MEMORANDUM

| To: | Steve Dobron, PE, City of Wenatchee | | |
| From: | Ryan Peterson, PE, PTOE, Transpo Group Bob Sisco, CDD, Transpo Group | | |
| Subject: | City of Wenatchee ADA Data Review and Proposed Data Dictionary | | |

Attachment A: Sidewalk Preliminary GIS Data Review

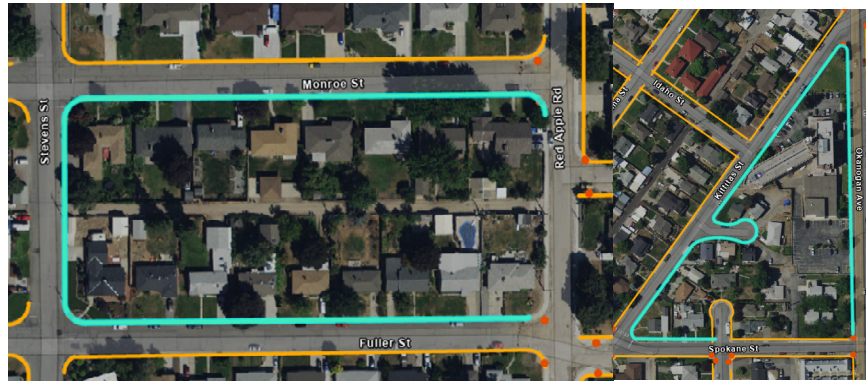
- Missing other valuable attribute fields typically needed for data collection / ADA self-evaluation
- Digitization Quality – Needs Improvement
 - Inconsistent digitization (orange lines = sidewalk, light blue lines = individual highlighted sidewalks)

- Not always split at mid-point curb return, sometimes 3 segments at curb return and sometimes just two with missing chunk in middle or one side sweeps across into next sidewalk

- Sometimes entire blocks are one line

- T-intersections usually aren't split as typical road centerlines are

- Have spotted some areas where there's missing sidewalk data/no digitizing

Attachment B: Curb Ramp Preliminary GIS Data Review

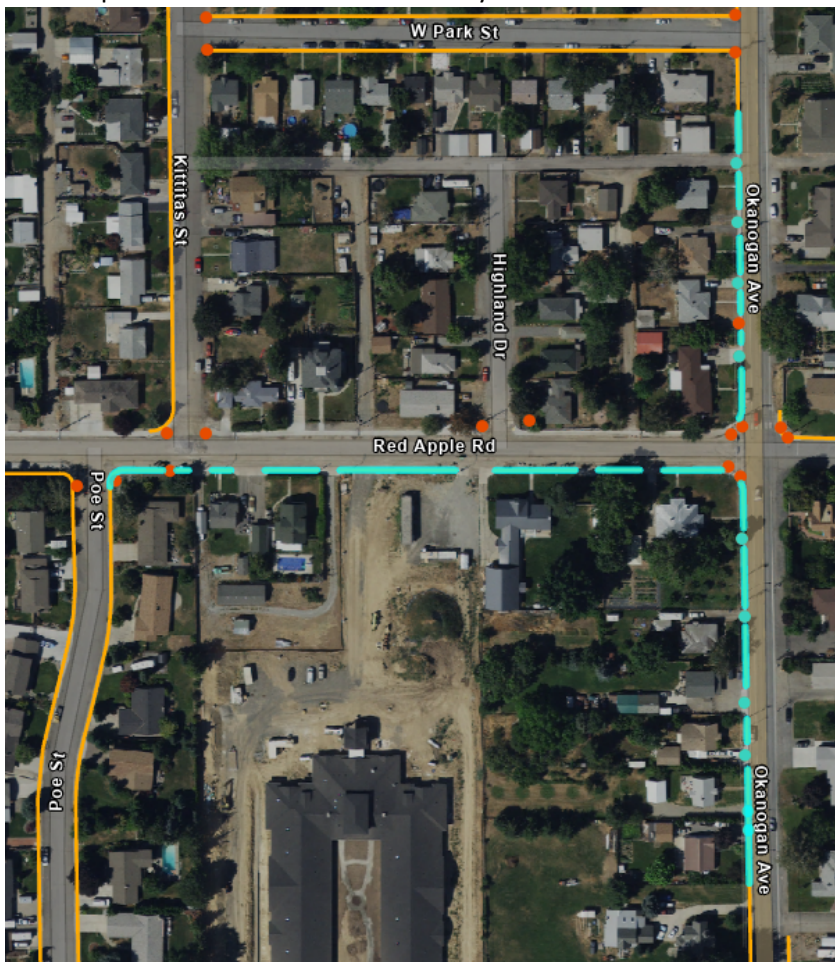
- Digitization Quality – Needs Improvement

- Placement is sometimes accurate then sometimes placed poorly (red dots = curb ramp)

- Some placement on or close to ramp's DWS, similar to how Transpo digitizes for asset management and inventory data collection

- No placements of missing ramps at PAR intersections as the data inventory normally has and needs for ADA Transition Plan cost estimating
- There appears to be at least a few ramps missing from the dataset

Attachment C: Push Button Preliminary GIS Data Review

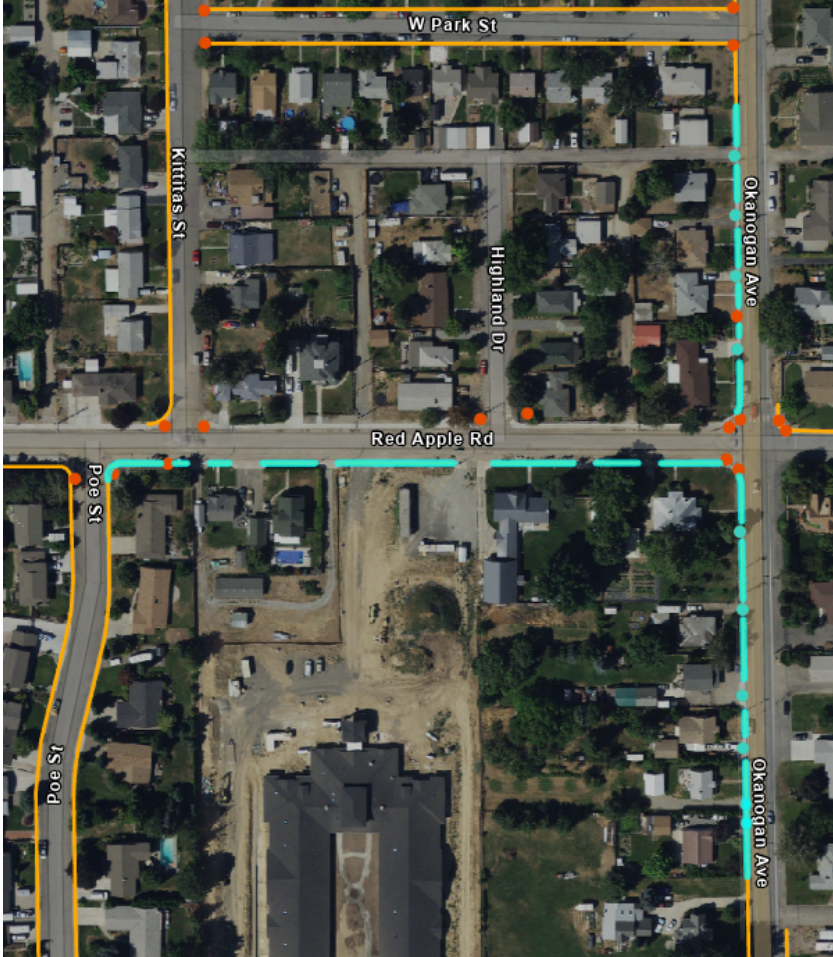
- Missing other valuable attribute field typically needed for data collection / ADA self-evaluation
- Digitization Quality – Needs Improvement
 - Inaccurate digitizing, often placed in the middle of intersections, but placed in a way where it could be possible to determine the intended location with careful inspection (blue dots = push button)
